# Access Compliance Report

## Public Rights-of-Way

### (Curb Ramps)

Intersection ID: 15247	Main Street: E_INDEPENDENCE_BV	Cross Street: EASTWAY_DR_RA	Location: SW
ADA ID: 013B839B5BF2	Ramp Type: Perp	Initial Pass/Fail: Pass	Overall Compliance: No
Severity Score: 20			
Codes/Mitigation Info/Possible Solution		Field Measurements/Component Compliance

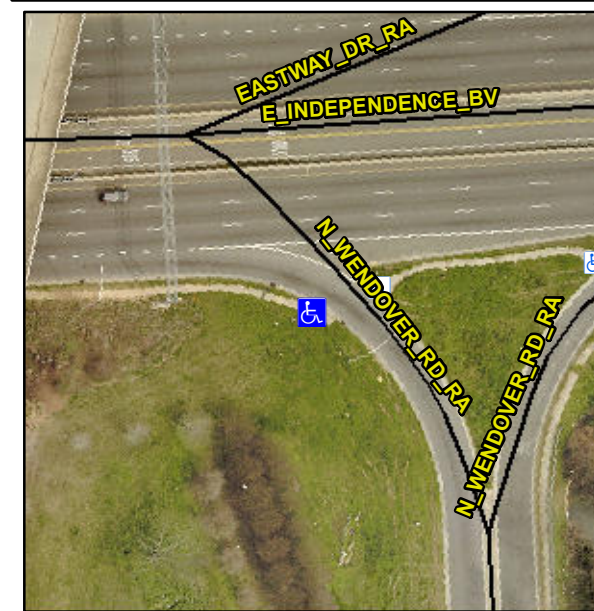
**Not Found, R304.2.1, R304.2.2-Perp, R304.3.2-Para, R304.5.3, R305.1.4, R305.2, R302.7, R302.7.2**

Compliance	Description	Data	Compliance	Description	Data
N/A	Ramp Length (in)	61.0	Yes	Ramp Slope (%)	6.6
Yes	Ramp Width (in)	50.0	Yes	Ramp XSlope (%)	1.1
N/A	Flare Type LT	Sloped	N/A	Flare Type RT	N/A
N/A	Flare Slope LT (%)	3.8	Yes	Flare Slope RT (%)	7.5
N/A	Flare Traversable LT?	Yes	N/A	Flare Traversable RT?	Yes
No	Landing Length (in)	N/A	Yes	DWS Provided?	Yes
No	Landing Width (in)	N/A	Yes	DWS Contrast?	Yes
No	Landing Slope (%)	N/A	Yes	DWS Length (in)	25.5
No	Landing X Slope (%)	N/A	No	DWS Full Width?	No
N/A	Landing Curb? (Y/N)	No	No	DWS Offset (in)	2.5
N/A	Shared Landing?	No			
No	Gutter Ponding?	Yes	Yes	Gutter Slope (%)	2.6
No	Gutter Lip Ht (in)	0.5	Yes	Gutter X Slope (%)	1.2
N/A	Painted X Walk1?	No	N/A	Painted X Walk2?	N/A
	X Walk 1 Direction	To NE		X Walk 2 Direction	N/A
N/A	X Walk 1 Width (in)	N/A	N/A	X Walk 2 Width (in)	N/A
	X Walk 1 Slope (%)	5.2		X Walk 2 Slope (%)	N/A
	X Walk 1 X Slope (%)	2.1		X Walk 2 X Slope (%)	N/A

N/A	Ramp inside XWalk1?	N/A	N/A	Ramp inside XWalk2?	N/A
	Road Slope (%)	N/A	N/A	Clear Space?	Yes
	Road X Slope (%)	N/A	N/A	Clear Space to XWalk (in)	N/A
Yes	Any Obstructions?	No	Yes	Storm Grate/Utility Hazard?	No
	Obstruction Type			Storm Grate/Utility Type	
		N/A			N/A
			Yes	Surface Condition? (G/P)	Good

**Remove & Replace Entire Ramp.**
